CITY OF ALBUQUERQUE

Re: Singing Arrow Community Center
13200 Wenonah Ave SE
30-Day Temporary Certificate of Occupancy
Transportation Development Final Inspection
Engineer's/Architect's Stamp dated 4-23-21(AA) (L22D055)
Certification dated 9-27-21

CITY OF ALBUQUERQUE / FAMILY & COMMUNITY SERVICES
SINGING ARROW COMMUNITY CENTER

C2 PARKING SIGNS

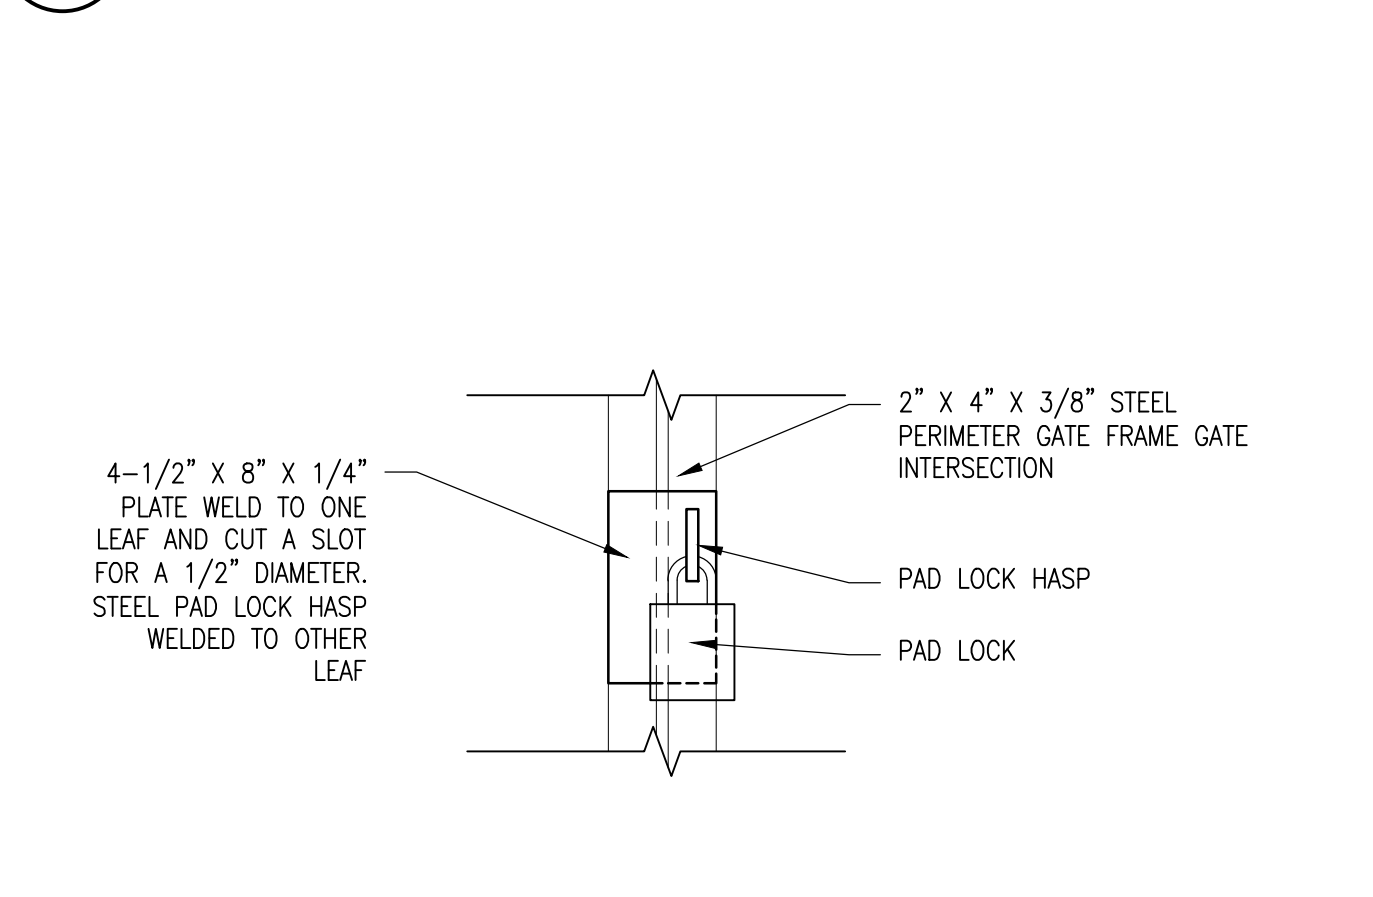
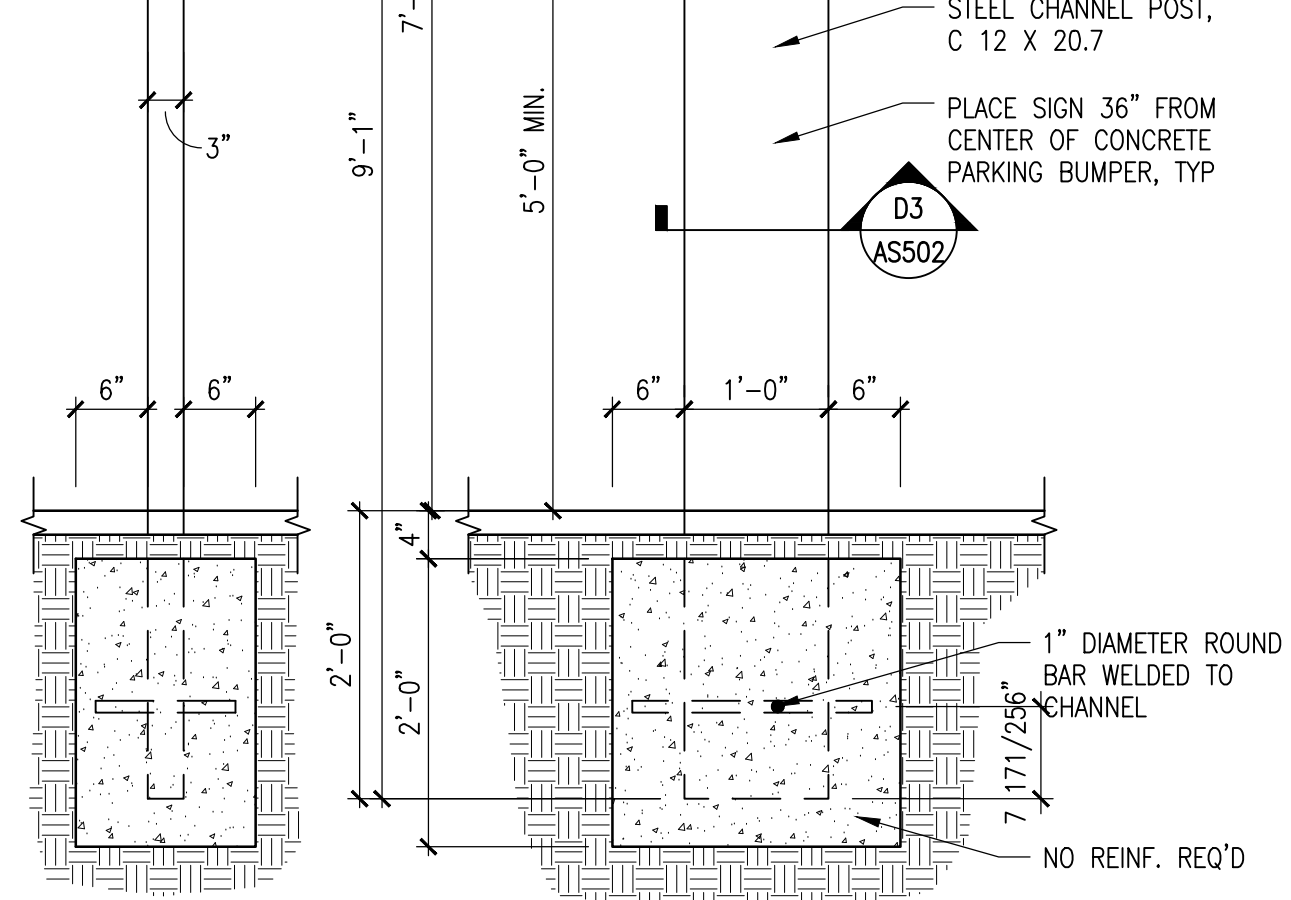
- Please add ADA signs. The ADA accessible parking sign must have the required language per 66-7-352.4C NMSA 1978 **"Violators Are Subject to a Fine and/or Towing."** If that language is present it is not visible in the detail.
- Remove security fence, landscape material in parking lot and construction equipment from site.

Once these corrections are complete, email pictures showing the corrections to epgomez@cabq.gov for release of Final CO.
